UNITED STATES ENVIRONMENTAL PROTECTION AGENCY  
WASHINGTON, D.C. 20460

R. Paul Detwiler, Acting Manager  
Carlsbad Field Office  
U.S. Department of Energy  
P.O. Box 3090  
Carlsbad, New Mexico 88221-3090

In a December 10, 2002, letter from Dr. Triay, the Department of Energy (DOE) requested our approval to dispose of standard waste and compressed waste from the Idaho National Environmental and Engineering Laboratory's (INEEL) Advanced Mixed Waste Treatment Facility (AMWTF) at the Waste Isolation Pilot Plant (WIPP). (Docket A-98-49, Item II-B2-15; all subsequent citations to same docket) We approved the disposal of standard transuranic waste from the AMWTF in a June 2003 letter, and recently approved related waste characterization processes at the facility. (II-B3-56, II-A4-42) Subject to EPA quality assurance and waste characterization inspections, with this letter we now approve disposal of compressed (super-compacted) waste at WIPP with the requirement to place additional magnesium oxide (MgO) with the compressed waste to maintain the current safety factor.

This report presents a Trinity Engineering Associates (TEA) review of the proposed U.S. Department of Energy (the Depar

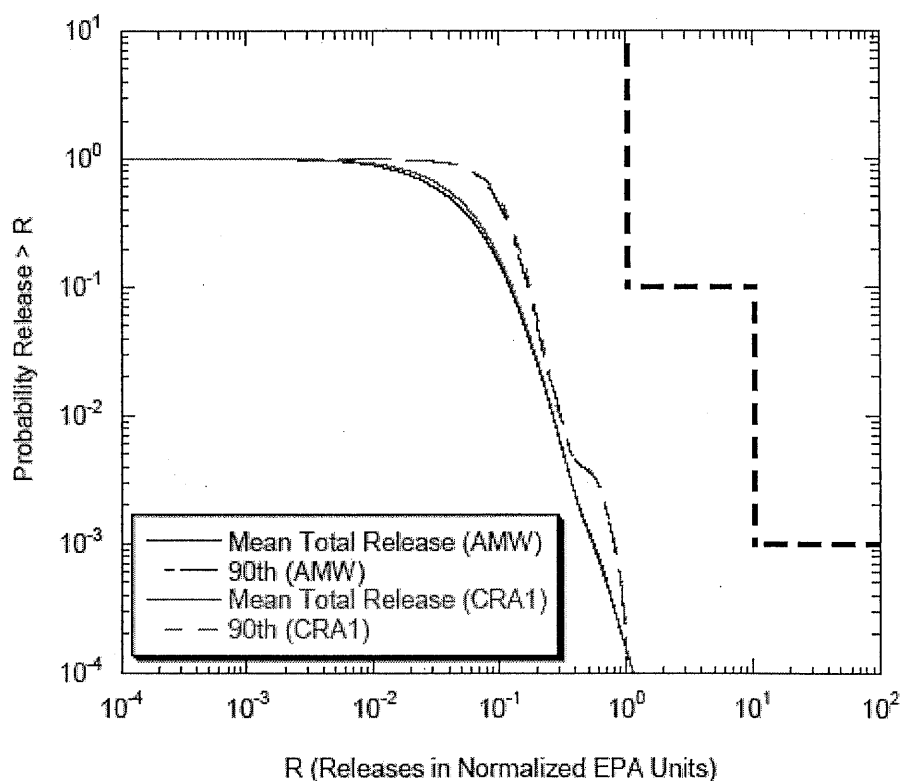
Since the AMW PA inventory and the 2004 CRA use the same inventory, DOE chose to compare the AMW PA with a modified CRA PA<sup>1</sup>. In this comparison, the set of CCDF (cumulative complementary distribution function) curves for total normalized releases are almost indistinguishable. The mean total releases and the 90<sup>th</sup> quantile releases are almost identical. The porosity concerns EPA identified in the review and discussed below should not affect these results because additional analyses showed that important results are not affected by use of constant porosity or porosity surface. EPA's concerns related to the uncertainty are satisfied with a review of the means and 90<sup>th</sup> quantile of total releases presented in Table 1 and Figure 2.

Figure 5-1. Minimum mass of MgO required per waste package.

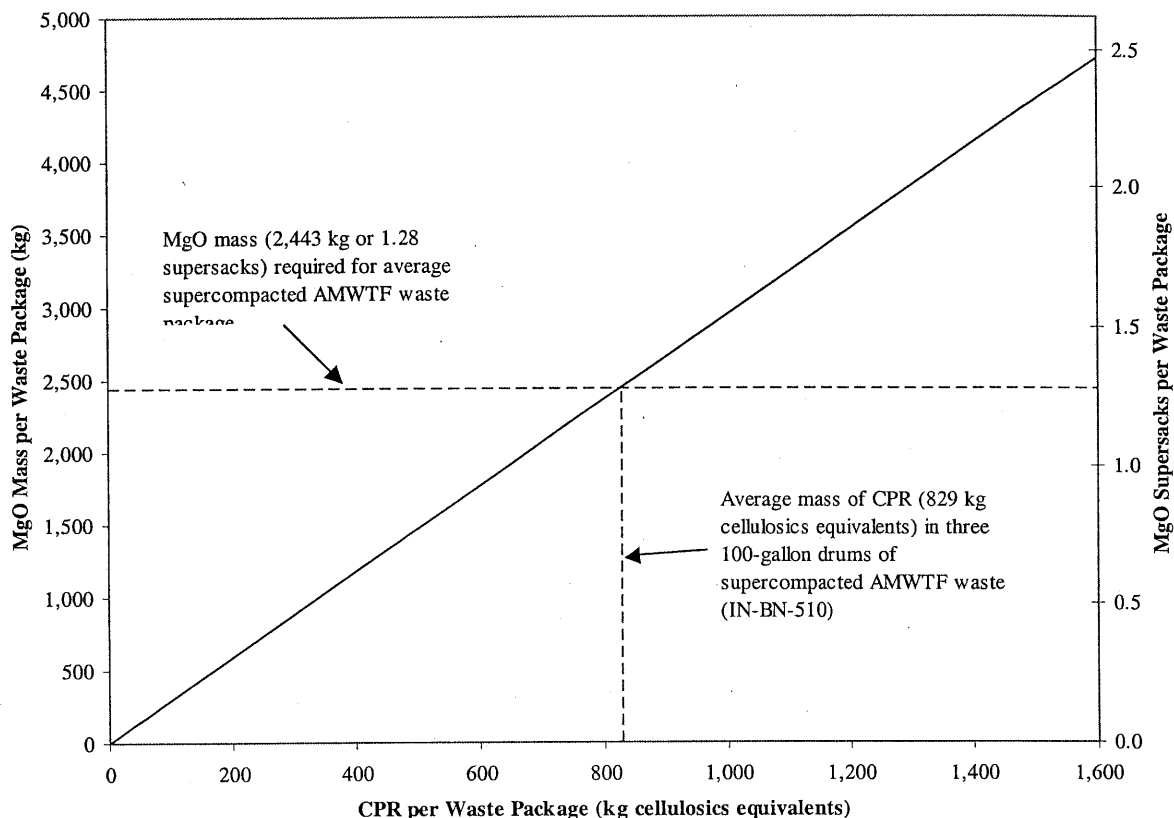
More MgO must be added to the repository than illustrated in Figure 5-1 to allow for the MgO dissolved in brine that may be released from the repository. Such releases can occur through anhydrite interbeds or intrusion boreholes and the MgO removed from the repository would not be available to react with CO<sub>2</sub>. The volume of brine that could leave the repository can conservatively be set equal to the volume of brine that could enter the repository. The amount of MgO that would be dissolved in the maximum volume of brine that could enter the repository is  $4.81 \times 10^5$  kg (Snider, 2003a and 2003b). This would require the placement of an additional 253 MgO supersacks in the repository.
